Smithfield - RH 'FRENCH COUNTRY' ELEVATION

156 DC - 452 Duncan Creek Rd., Lillington, NC 27546

9-28-24 - Redlines - JJ

THE SMITHFIELD - RH

FIRST FLOOR PLAN 'FRENCH COUNTRY'
 SCALE: 1/8"=1'-0" ON 11x17, 1/4"=1'-0" ON 22x34

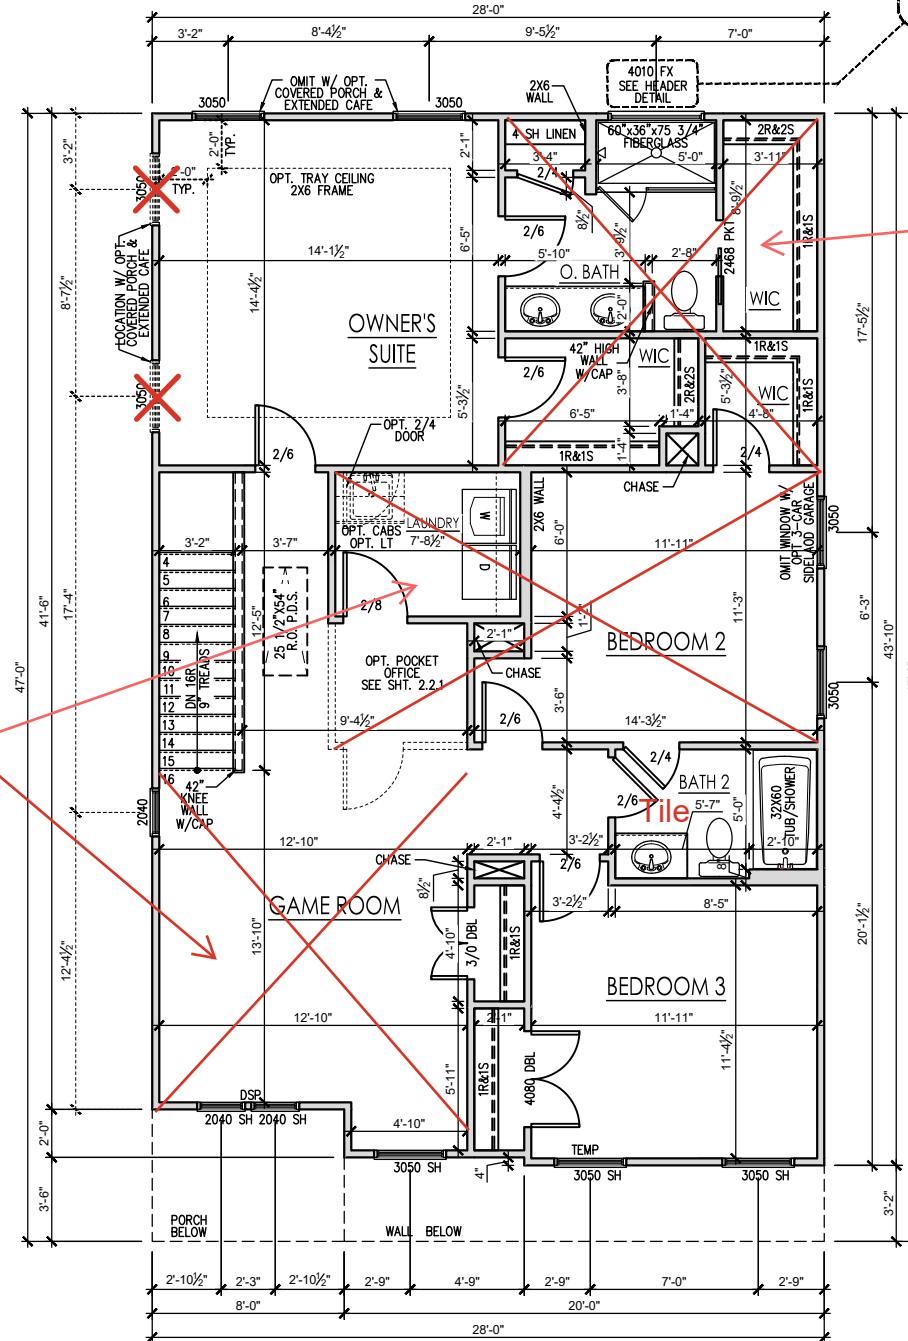
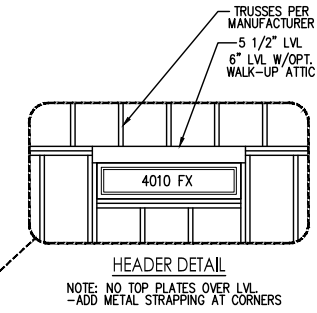
2.2.1b for Owner's Bath

2.2.1b for laundry, pocket office bedroom 2 and bedroom 4

"FRENCH COUNTRY" ROOF PLAN

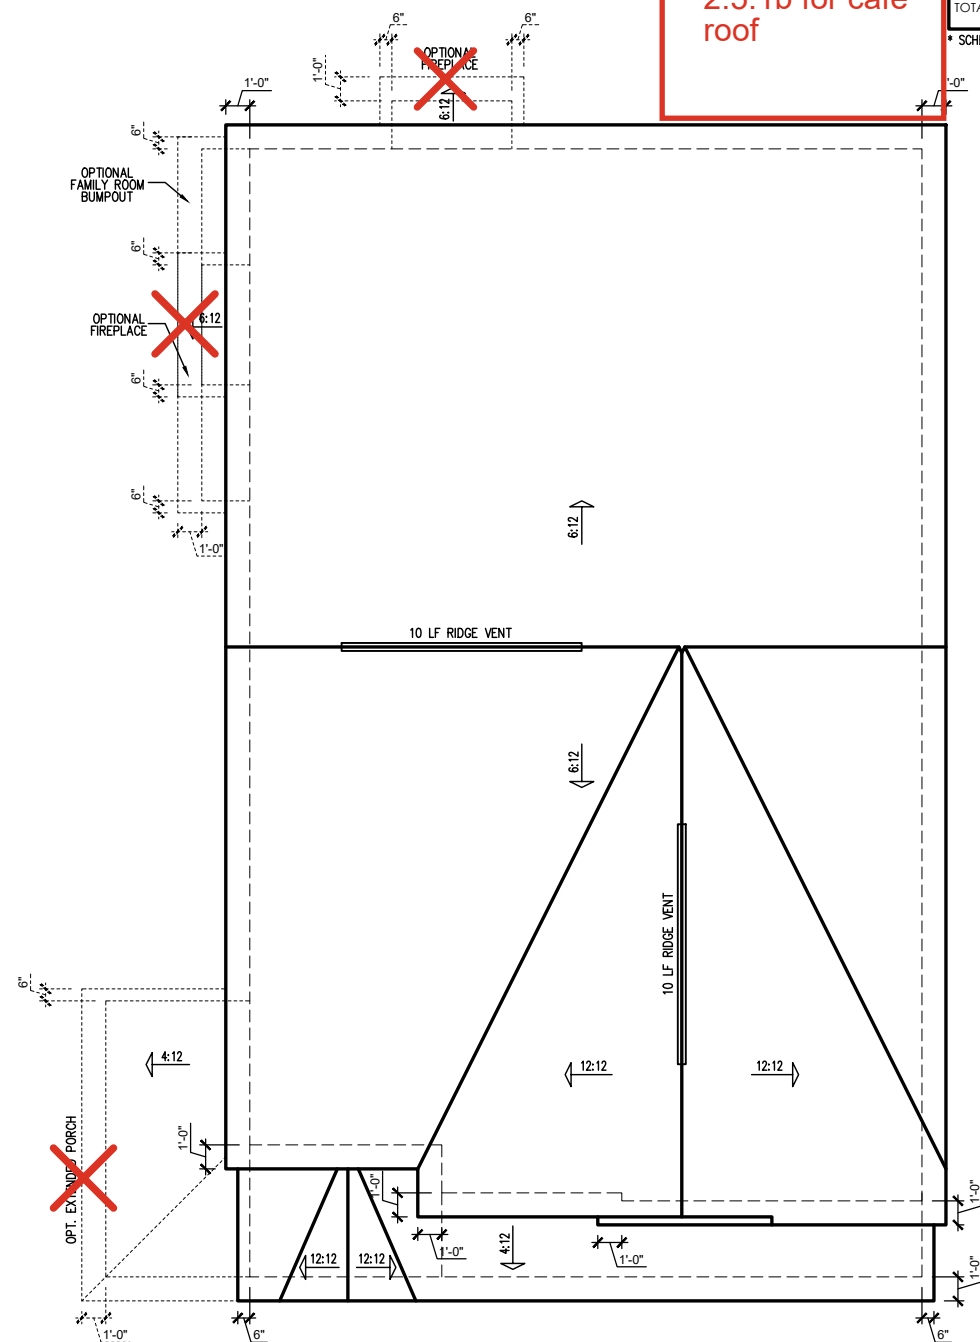
2.5.1b for cafe roof

CRAWL FOUNDATION PLAN "FRENCH COUNTRY"

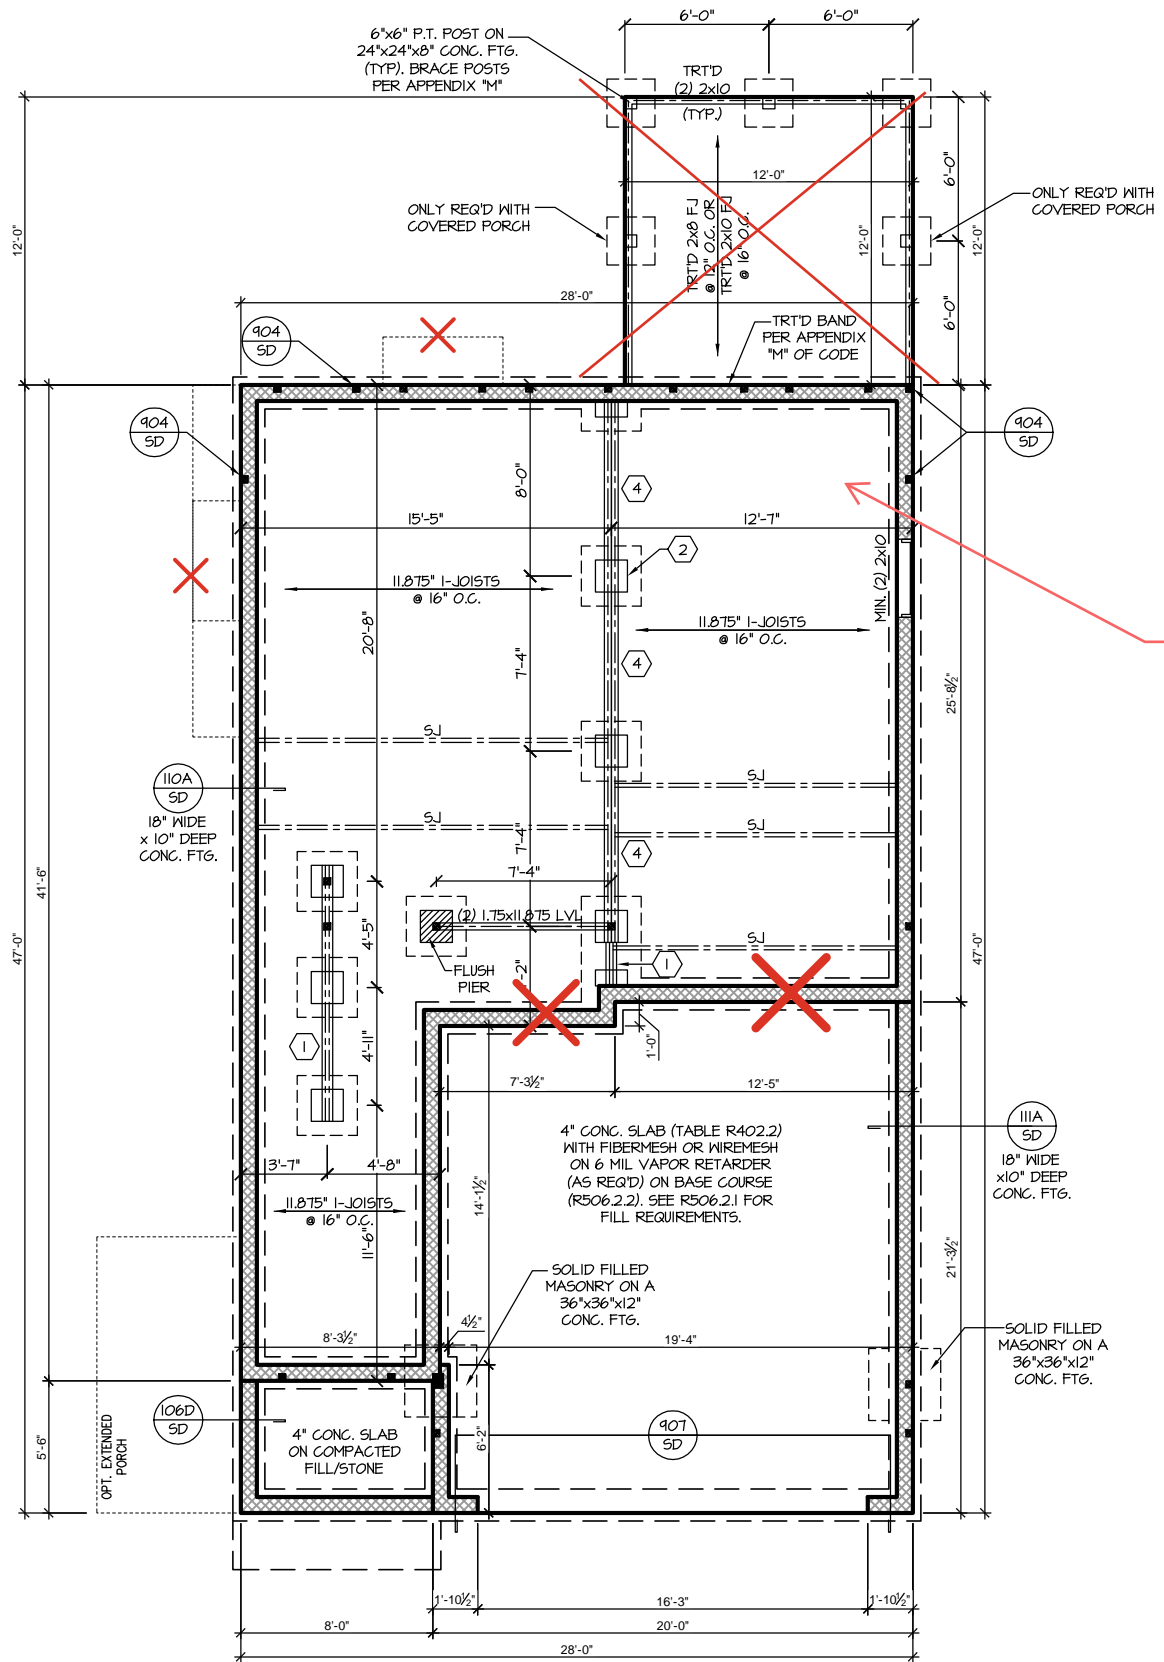
S1.2.1 for ext. cafe foundation

FIRST FLOOR PLAN "FRENCH COUNTRY"

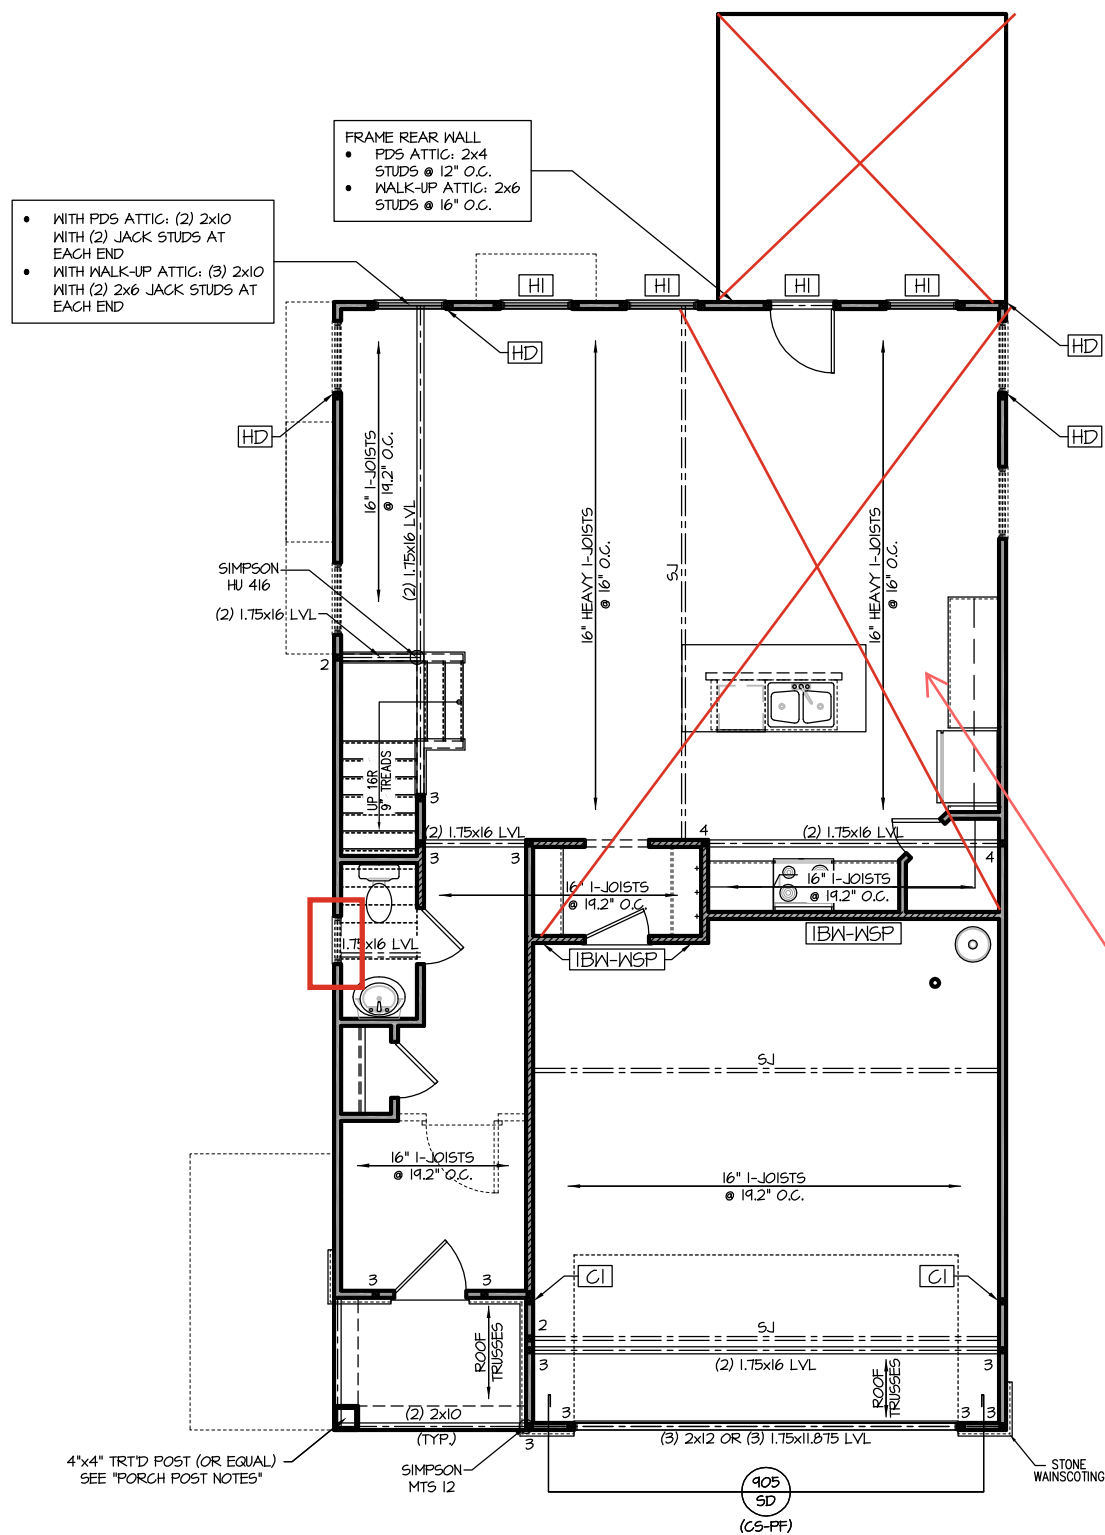
S-2.1.1 for kitchen with ext. cafe
